From: Price, John E [<mailto:jeprice@STPEGS.COM>]
Sent: Monday, August 08, 2011 10:09 AM
To: Tai, Tom
Cc: Thomas, Brian; Chakrabarti, Samir; Chakravorty, Manas; Head, Scott
Subject: Section 3.7 & 3.8 Actions - Updated August 5, 2011

Punch List for South Texas Project Units 3 & 4
Sections 3.7 & 3.8

**South Texas Project Units 3 & 4
Clarifications from NRC**

Issue 8: [Received 04/04/2011] (Audit Action Item 3.7-33 and 35) Stability Analysis Procedure

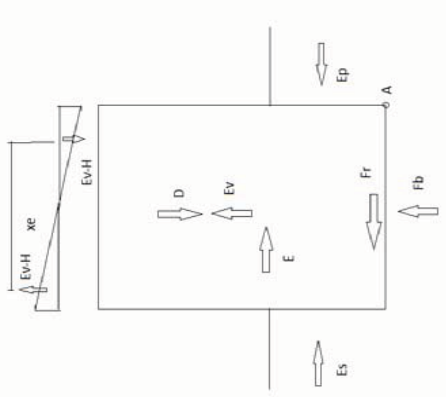
A brief presentation of the stability analysis procedure was made by the applicant during the March 14, 2011 audit. The presentation included a rigid body diagram showing the forces acting on the structure for stability calculations. The applicant indicated that the total seismic demand is calculated by summing all the inertia forces and moments acting on the structure. These inertia forces are calculated by multiplying the mass of each node by the absolute value of the maximum acceleration response at that node obtained from the SSI analysis.

The calculation of the seismic overturning moment is based on the horizontal seismic load E and vertical seismic load Ev about tipping point A, as shown in the figure below. The moment due to horizontal earthquake does not include Ev-H (vertical force due to horizontal input) which also produces overturning moment about A. The applicant is requested to provide justification for not including the vertical component of response due to horizontal seismic input in calculating the foundation overturning moment.
